Application: A413, A470, A670 Lockup Torque Converters (89-up)

Subject: Converter housing rubs against oil pump body

Technical Bulletin

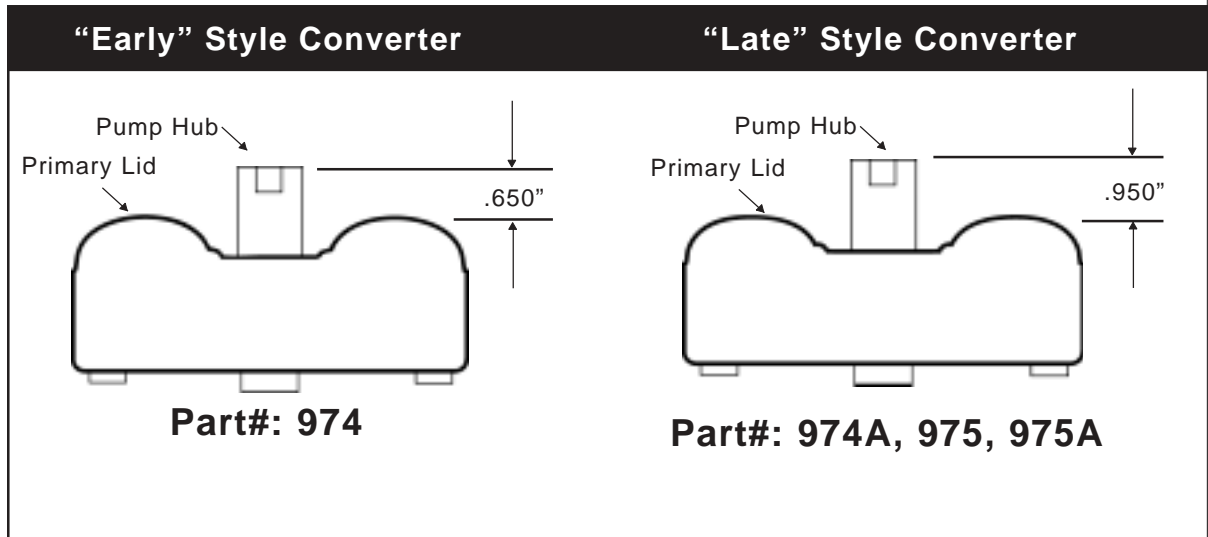
The pump body casting for A470, A670 Chrysler Lockup transmissions changed in 1989. Chrysler A470, A670 converters will rub against the transmission oil pump housing if an "early" style (974) converter is installed with a "late" 1989-up pump body.

The late style converter (974A, 975, 975A) measures .950" from the top of the pump hub to the top of the primary lid and will not rub against the late pump body. Late style converters will retro back to replace early style converters; just match the stall speed and they will interchange with no problems.
